# CITY PLAN COMMISSION STAFF REPORT

**Project Name**  
Skyview Industrial

**Request**  
CD-CPC-2023-00018  
Development Plan – Non-Residential

Docket #9 Approval with Conditions

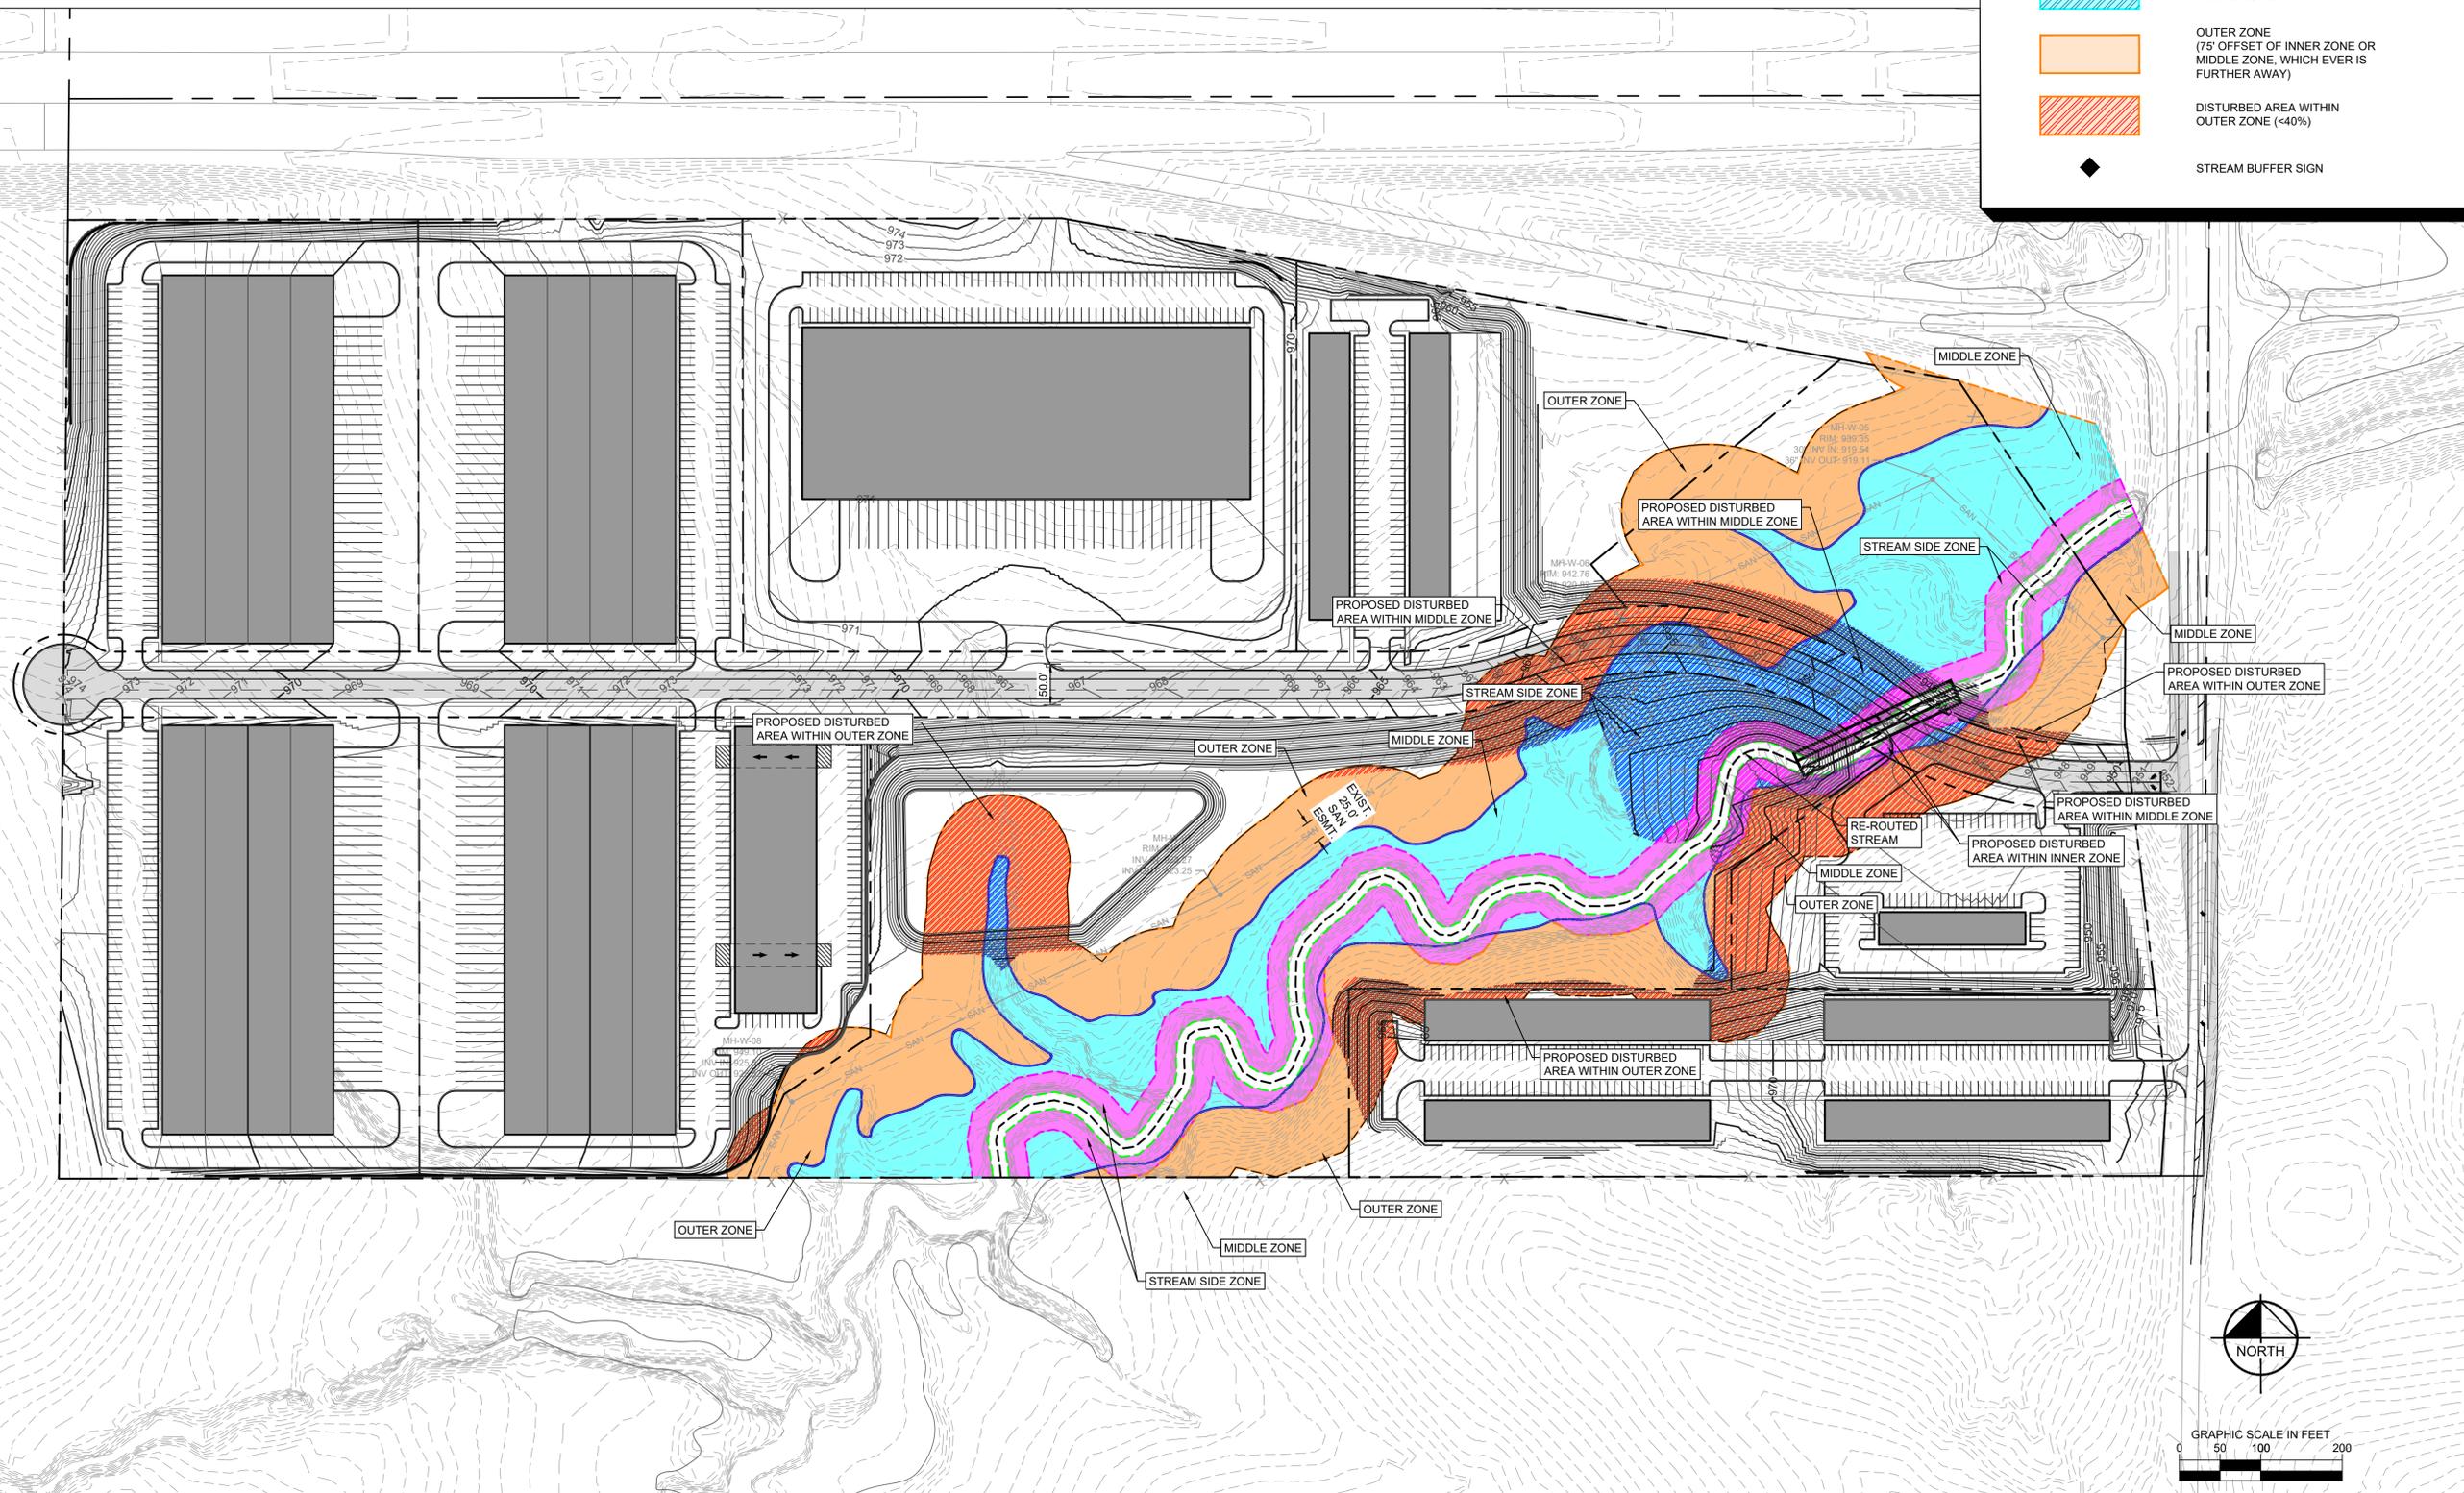
31. The proposed Stream Reroute needs to be approved by FEMA prior to Approval of Final Stream Buffer Plans and prior to the issuance of any permits.
